SEWAGE DISPOSAL SYSTEM  
HOWARD COUNTY HEALTH DEPARTMENT  
BUREAU OF ENVIRONMENTAL HEALTH  
410-313-2640

P 515347

A REPAIR

SUBDIVISION Berndell Estates LOT NUMBER 11 ADDRESS 875 Windriver Drive

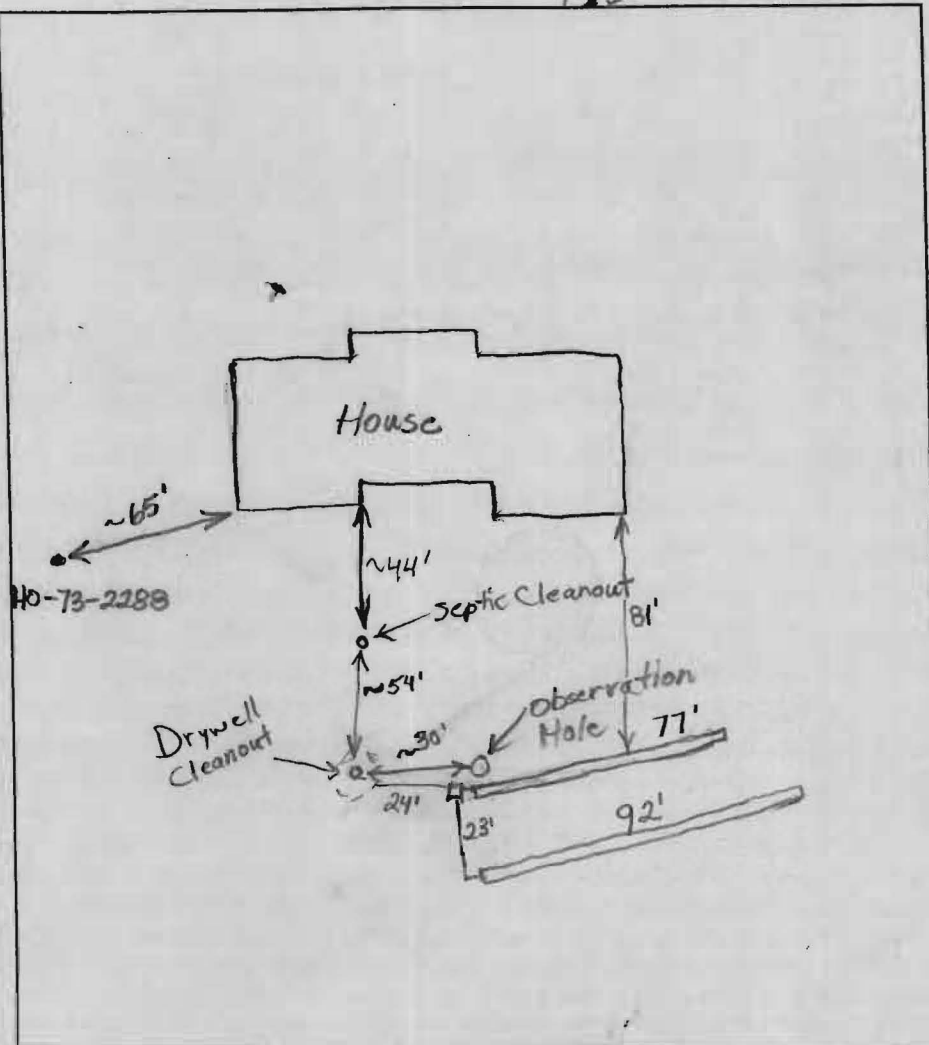
Windriver Drive  
 PRE-CONSTRUCTION INSPECTION: 7/16/01 To install 2 trenches off of distribution box coming from drywell. Trenches 9.5'-10' deep with 5' off stone. (BB)

INSPECTION COMMENTS: 7/16/01 Arrived when first trench done. Second trench 1' shallower than required stone depth. Told contractor to make second trench 15' longer to compensate. Trenches slightly off contour, bottom depth and inlet depth vary. (BB)
